Stage 04: Code Administrator Consultation

CMP213 Project TransmiT TNUoS Developments

Consultation Responses

Zone Z

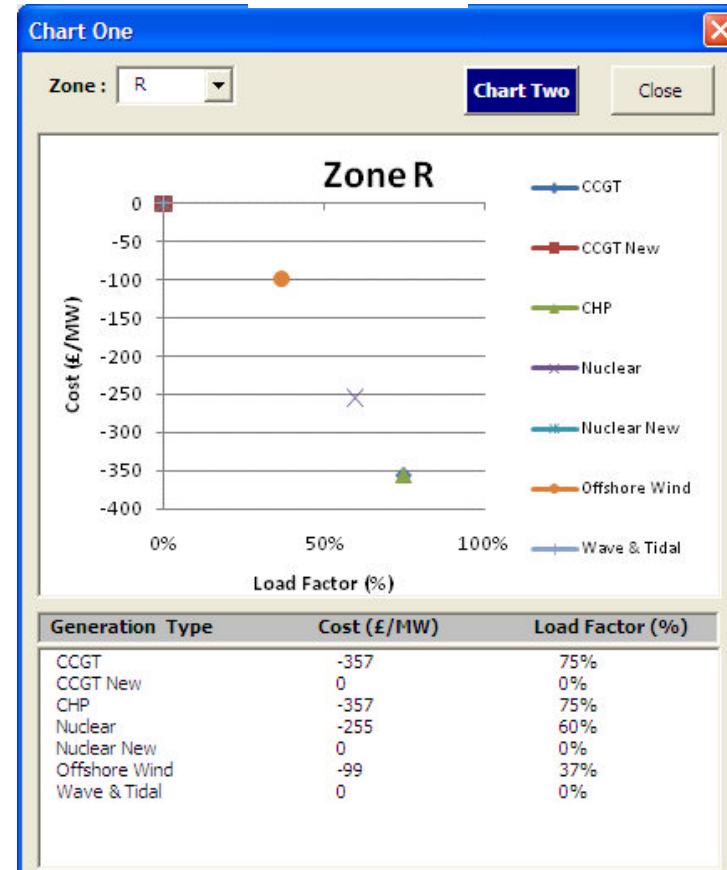
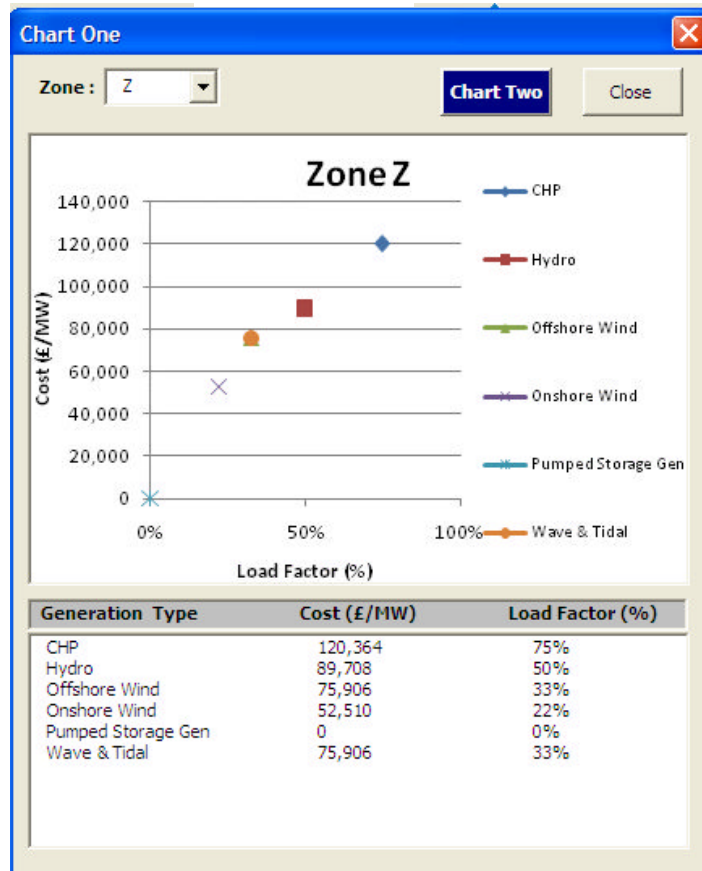
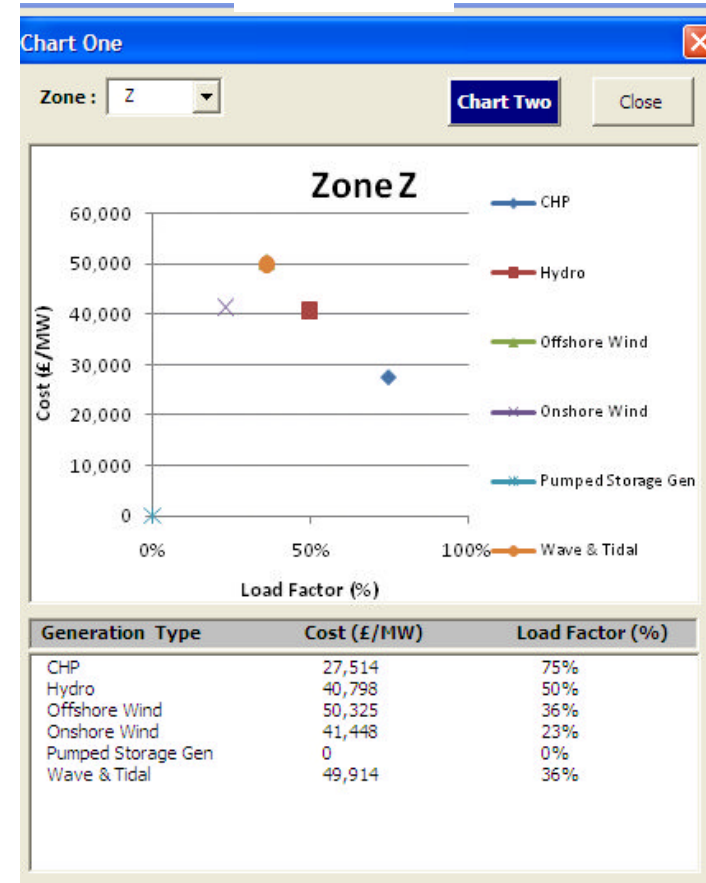
The evidence which is used to demonstrate this linearity is typically based on a 2011/12 generation background (inc. that on pages 176 to 179 of the workgroup consultation document). Analysis undertaken by Centrica using the ELSI model using 2015/16 input data (including boundary capacity data from the Seven Year Statement) show no distinguishable linearity between load factor and constraint costs in the majority of zones (please see the annex). Examining the relationship between load factor and incremental constraint costs the ELSI model produces on a 2015/16 background is important because it is, for obvious reasons, a more relevant time period than 2011/12. The breakdown of any perceivable relationship by 2015 should be examined by the Working Group.

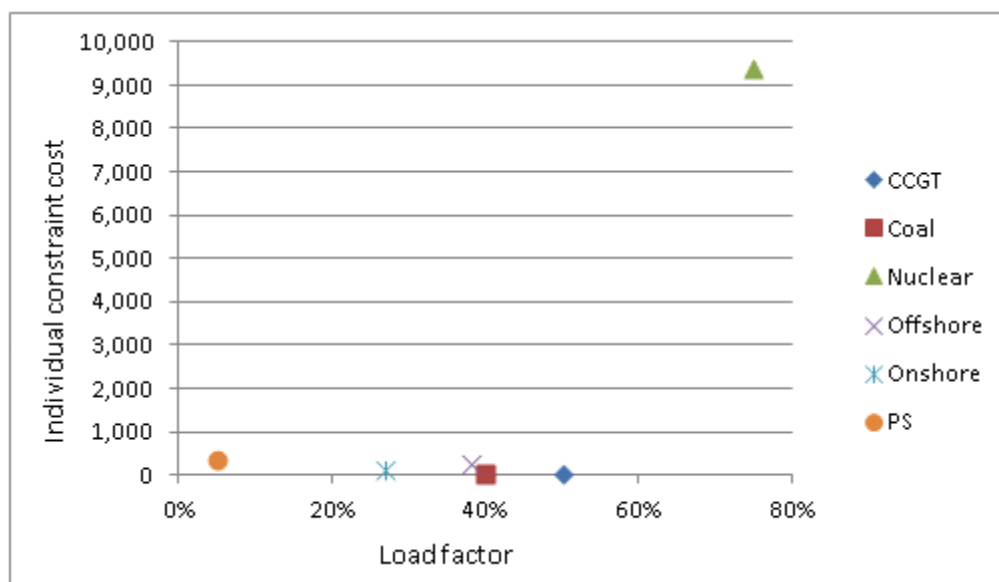
For example, we disagree with the proposition as illustrated in Figures 17, 18, 19, 20, 21, that there is one linear relationship between the load factor and incremental constraint costs of low carbon plant and a different linear relationship for non low carbon plant. We do not think that this has been clearly demonstrated and seems at odds with examination of actual bids and associated constraint costs.

A further anomaly with this approach is that it appears that pump storage generation (where some Bid prices are higher than, for example, non nuclear low carbon generation) is included with non low carbon plant even though the range of offer prices is greater than the 1-2.4% range between non nuclear low carbon generation and non low carbon plant.

As a result we have serious reservations over some of the detail in the proposed 'diversity' approach set out in paragraphs 4.123-4.150 as it appears to distort the effect of the proposal by substantially altering the quantity of transmission capacity that is available to share between generators (especially in Scotland, and in particular the B6 Cheviot boundary).

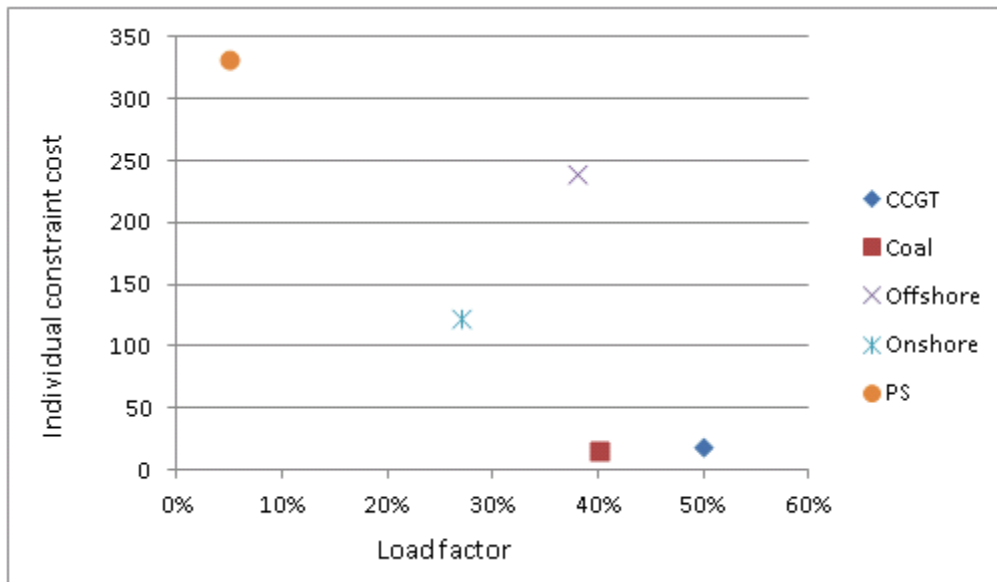
We have reviewed bid prices for a range of plant, covering over 17 GW of plant, for one month from 24/11/12 to 24/12/12. (This period has been used as it is the most recent month available excluding the Christmas holiday period). In the following graph we show the calculated marginal constraint cost associated with these bids. This shows that there is not a strong relationship between plant load factor and bid cost according to the definition carbon and low carbon. The relationship is not clear as the bid cost of nuclear is so much lower than that for the other technology types.

Using a truncated scale for the constraint cost (y-axis) helps outline the relationship for the non-nuclear plant. Nuclear plant is excluded as its constraint cost is outwith the y-axis range. It is clear that the relationship between load factor and constraint cost does not split along carbon and low carbon lines.
